REFERENCE:	Nova Bus Manuals
SECTION:	16: 24-Volt Electrical System
RS N°:	N/A
EFFECTIVE IN PROD.:	L621 (2011AL)

APPLICATION DEADLINE: 2016JL31
CLAIM REFERENCE NUMBER: WB-3080

SUBJECT:	V-BEA module
JUSTIFICATION:	CECM could be replace with a MCM module to reduce download time

Figure 1 - Typical Overhead Console Panel

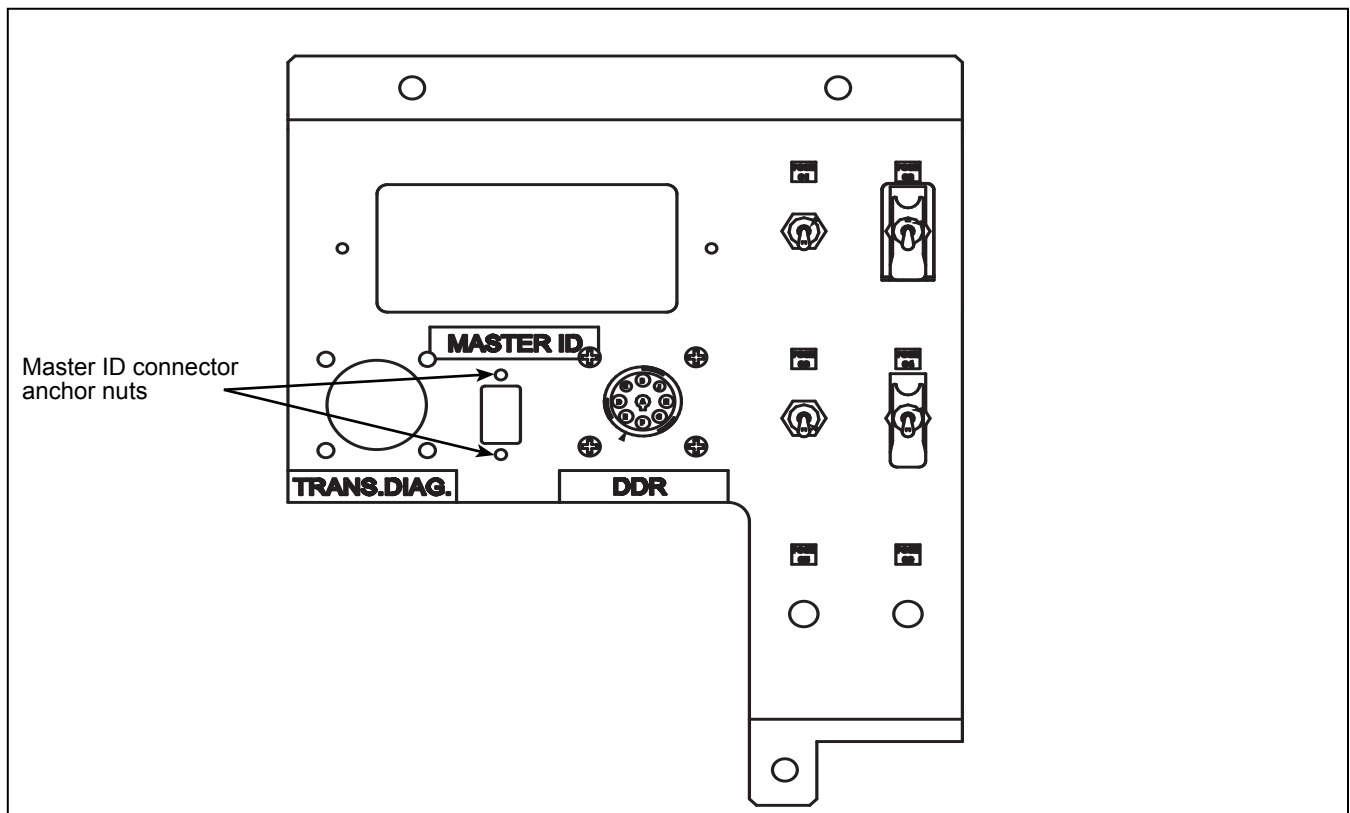
- 1.1. Remove the operator's partition panel. Retain the panel and the hardware.
- 1.2. Remove the operator's control panel rear access door.
- 1.3. Open the overhead console door, located above the operator's window.
- 1.4. With a 5 mm (3/16 in.) nut driver, remove the Master ID anchor nuts from the overhead console panel. Retain the hardware. See Figure 1.
- 1.5. Install the female connector of the new cable N81735 in the Master ID position on the overhead console panel. Use the retained hardware to attach the connector using a 5 mm (3/16 in.) nut driver. See Figure 1.

Figure 2 - Connection of Cable N81735 to Blue MCM Module Blue Connector

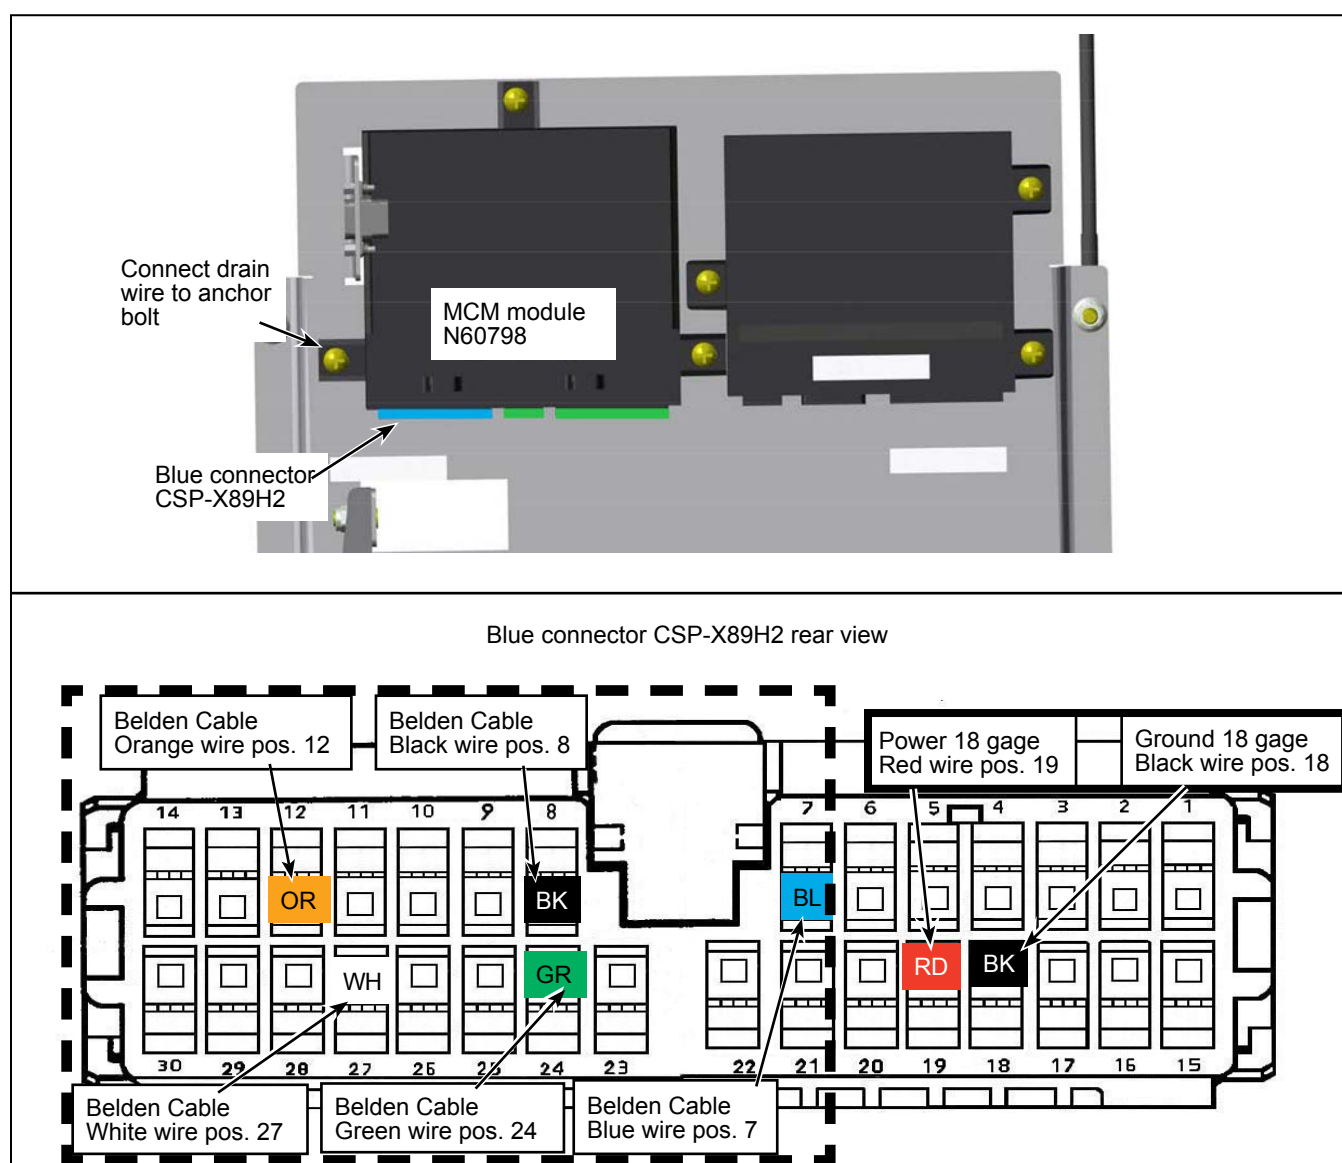
- 1.6. Route and connect the portion tag **TO MCM** of cable N81735 to **BLUE** MCM connector **CSP-X89H2** in the operator's control panel. Secure the cable with tie wraps along the routing. See Figure 2.

- 1.7. Disconnect the blue MCM connector **CSP-X89H2** from the CECM module. See Figure 2.
- 1.8. Connect all colored wires (green, white, orange, blue, red and 2 black) of cable N81735 to connector **CSP-X89H2**. See Figure 2 for pin position.

- 1.9. Replace CECM module with new MCM module N60798, using the same hardware. See Figure 2.
- 1.10. Connect the drain wire of cable N81735 to the bottom left anchor bolts of MCM module N60798. See Figure 2.

Figure 3 - Cable N64011 and N64009 Connection in Main Panel

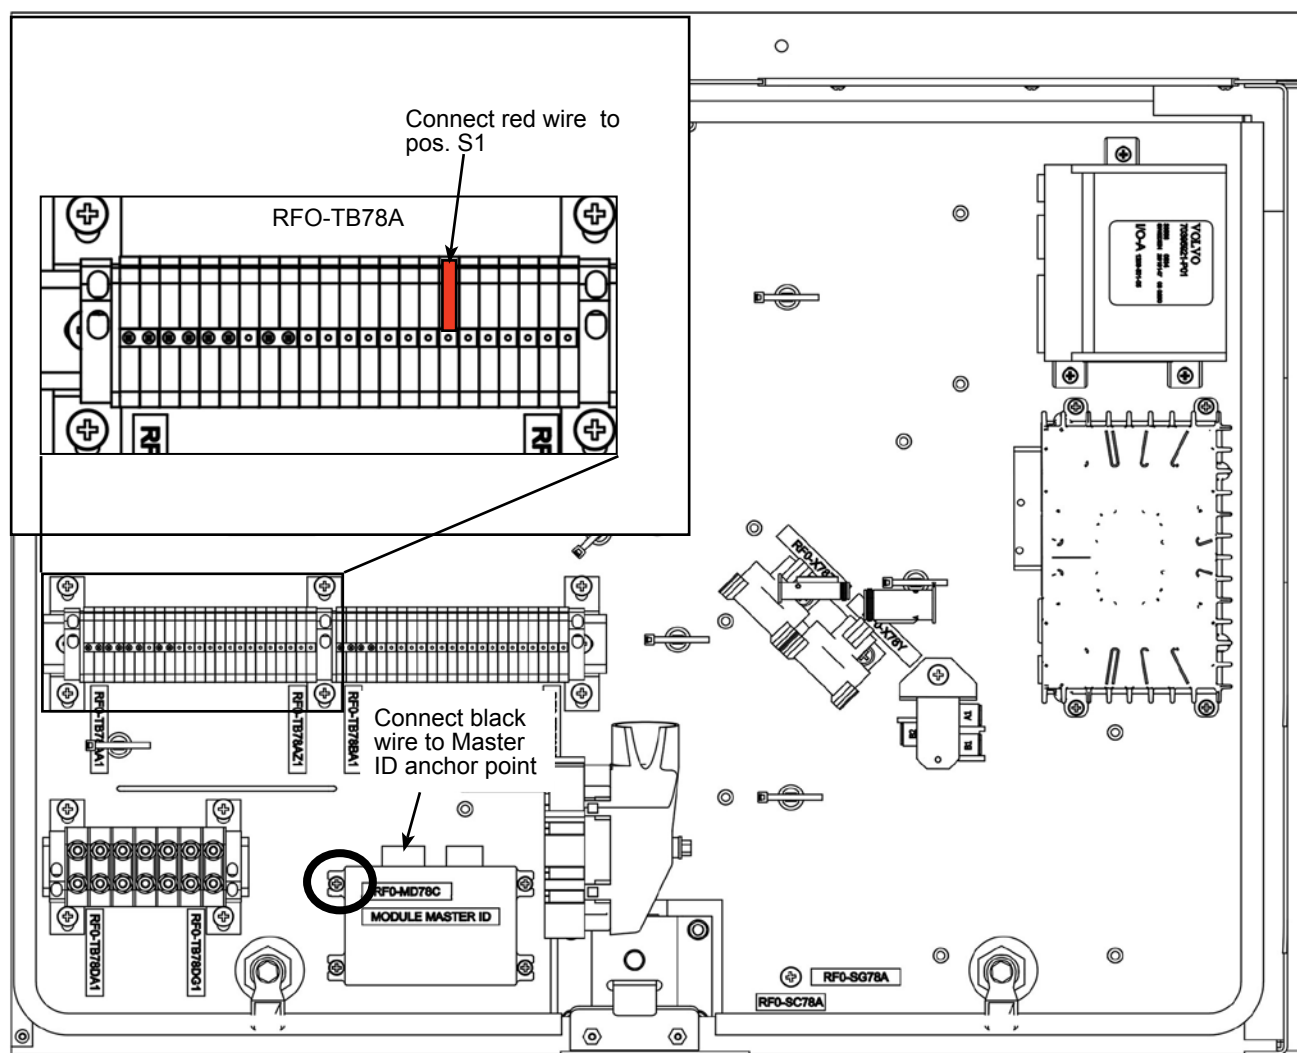
- 1.14. Connect the red wire tagged **To BAT 24V SWITCHED** of cable N81735 to main panel terminal block RFO-TB78A-S1. See Figure 3.
- 1.15. Remove and discard the **MASTER ID**. Retain the hardware.
- 1.16. Connect the black wire tagged **To GND** of cable N81735 to one of the anchor points used to maintain the **MASTER ID**. See Figure 3.
- 1.17. Disconnect cable **RF0-x78c2** from the Master ID module. See Figure 3.
- 1.18. Close the left electrical main panel doors.

Figure 7 -

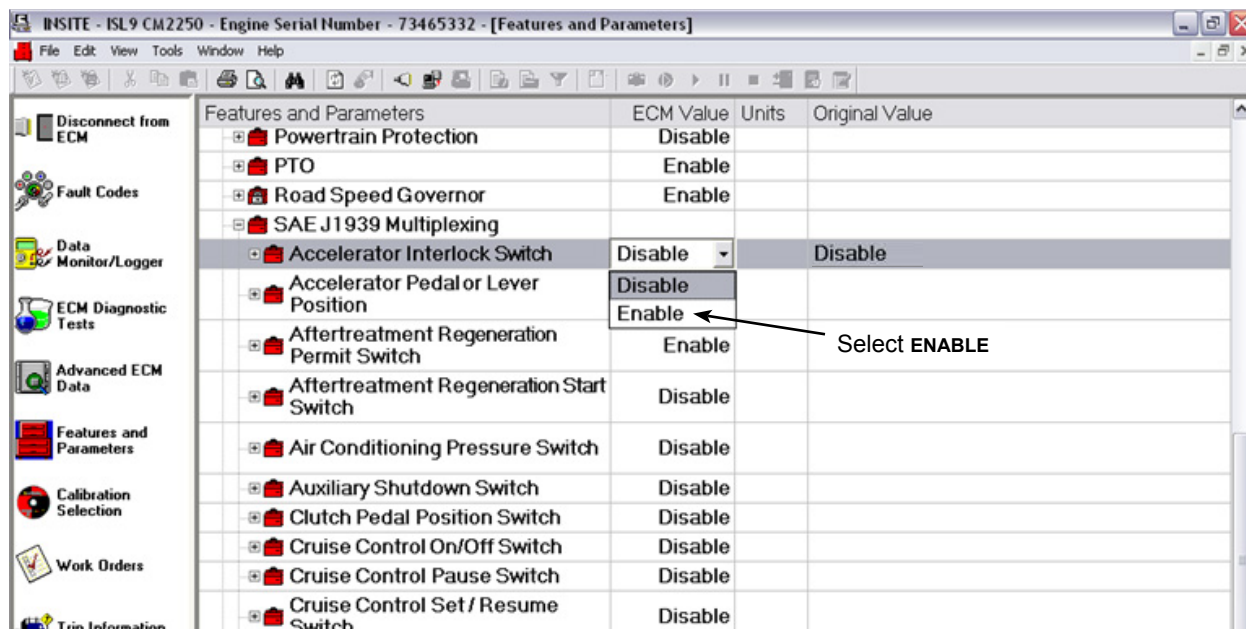
- 3.7. Change the **ACCELERATOR INTERLOCK SWITCH** parameter from **DISABLE** to **ENABLE**. See Figure 7.
